26 July 2011

Our ref: 21/19757/171590
Your ref:

Kimbriki Resource Recovery Project Response to Submissions Report

Figure 2 – Updated Vegetation Communities map showing EEC Coastal Upland Swamp species

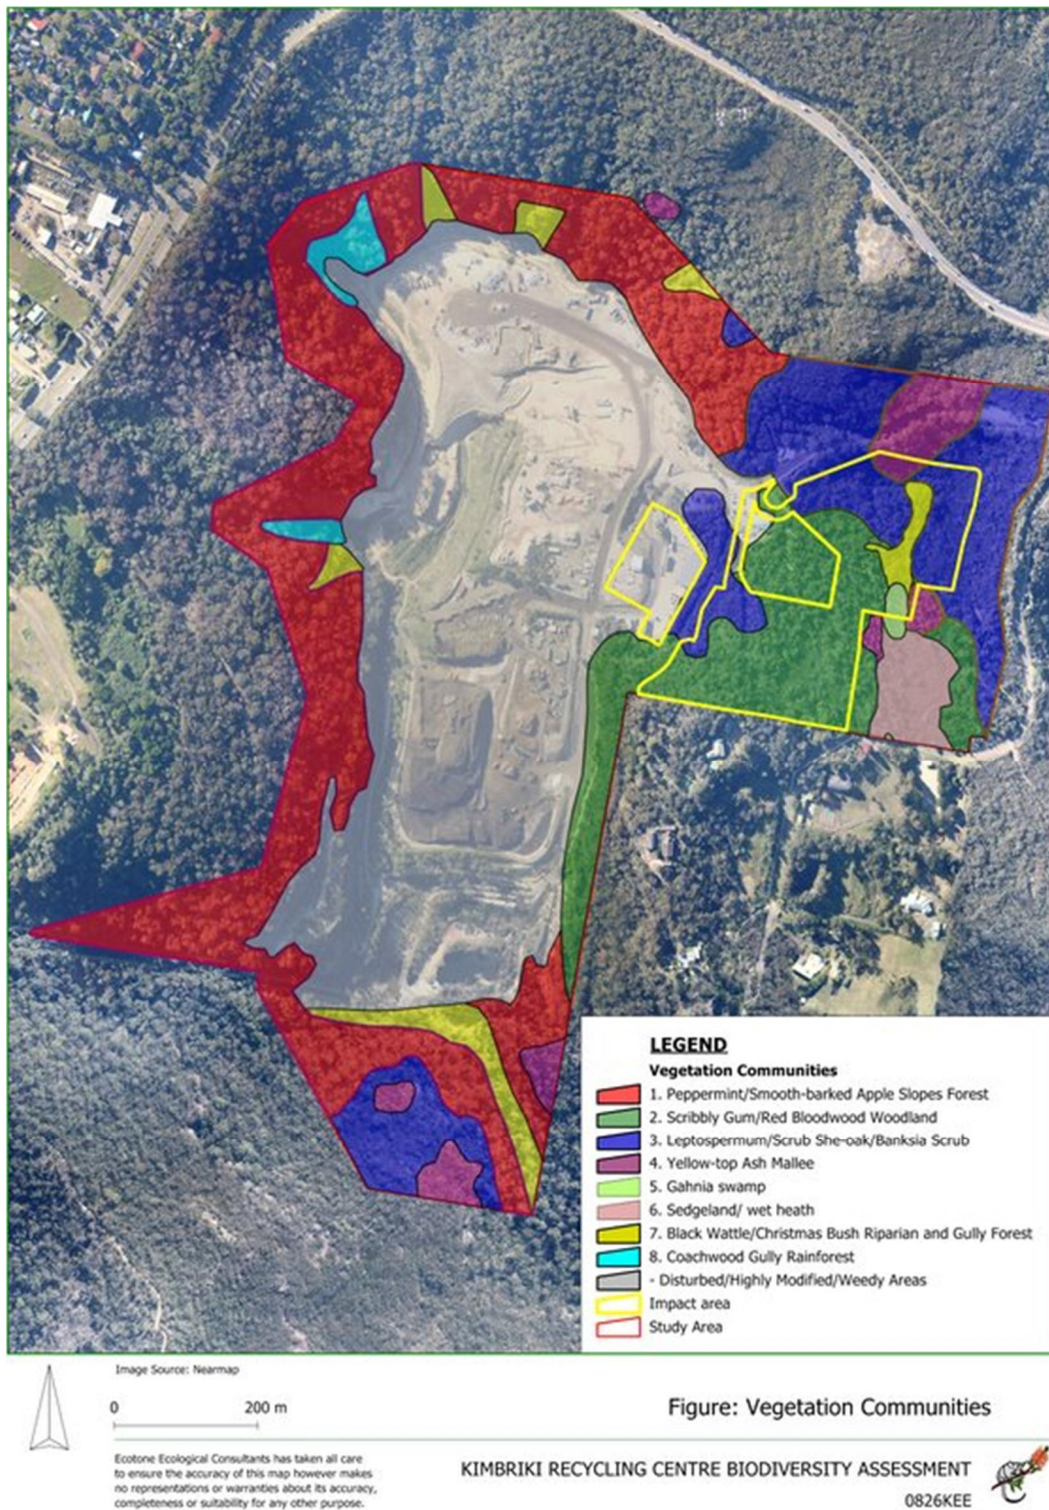
The Gahnia swamp and therefore the Coastal Upland Swamp is considered to extend an additional 30m north from that shown on Figure 1 – Drainage Path Vegetation Assessment in the Submission Report (KEE/GHD).

Ecotone, KEE's ecological consultant, has mapped the extent of the Coastal Upland Swamp, and it is shown on Figure 2, with the original platform layout. This shows how much of the swamp was affected by the original platform layout. It does not appear to extend an additional 30 m north of the area shown on Figure 1 in the SR.

The final platform layout shown in Figure 1 will preserve the Ghania swamp, which is part of the interim listed EEC Coastal Upland Swamp.

Figure 4 – Revised offset strategy, restricted activity areas and (long-term) rehabilitation areas

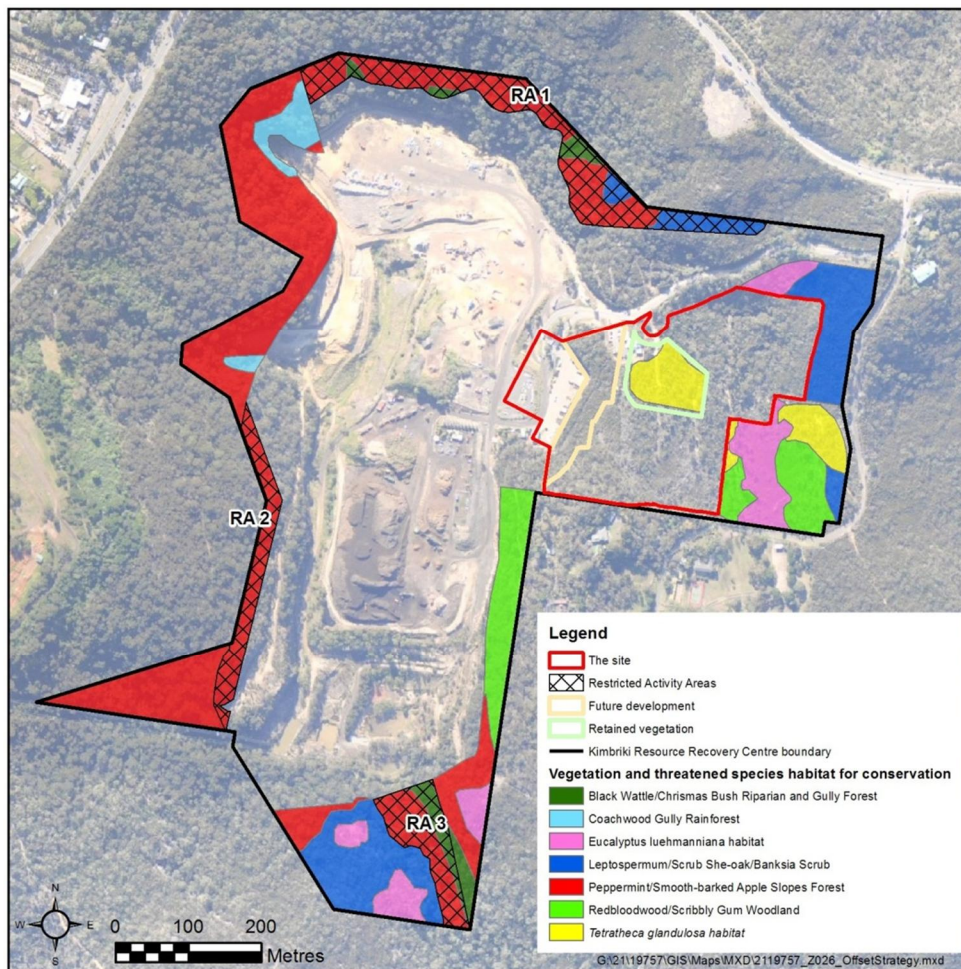
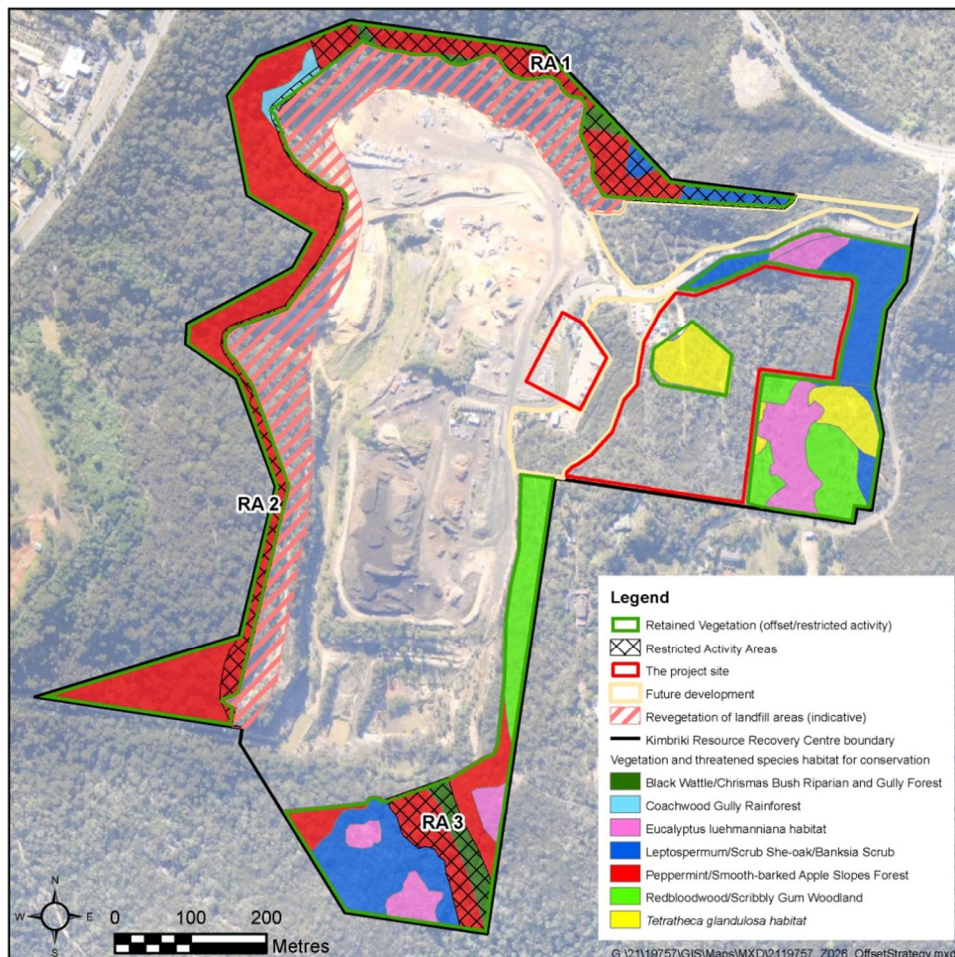
Some adjustments have been made to the proposed offset strategy for the project, to ensure that the proposed offset strategy is consistent with the original consent (Development Consent 96/371) for the overall Kimbriki site, which defined areas approved for future quarrying and landfilling.

The offset areas proposed in the EA had not taken account of the operational areas defined in the 1996 consent. This only became apparent recently during preparation of a Master Plan for the Kimbriki site. To avoid possible confusion in future between offset areas and operational areas, these adjustments have been made, and the offset areas shown on the attached plan (Figure 2) are anticipated will become part of the EA Consent.

The original proposed strategy in the EA (along with identified restricted activity areas) and the adjusted offset strategy are both shown in Figure 3 and Figure 4 respectively.

The adjustments to the offset areas on the western side of the site (due to the need to align offset areas with operational areas defined in the 1996 consent), result in a reduction of 0.73 ha in the vegetation retained as offsets near the landfilling areas. However, this is partially offset by an increase of 0.31 ha in environmental offsets on or adjacent to the project site, resulting in a net vegetation loss across the entire KEE site, of 0.42 ha.

However this reduction in overall vegetation has no effect on vegetation communities disturbed by the project, as the areas of vegetation that is no longer included in the offset areas comprise species that are not present in the project area (Peppermint/Smooth-barked Apple Slopes Forest and Coachwood Gully Rainforest), and are commonly found in the vicinity of the Kimbriki site and in the region. As shown in Table 2, the overall offset ratio associated with the project increases from 2.56:1 to 2.60:1, due to the preservation of additional *Eucalyptus luehmanniana* habitat and Redbloodwood/Scribbly Gum Woodland.
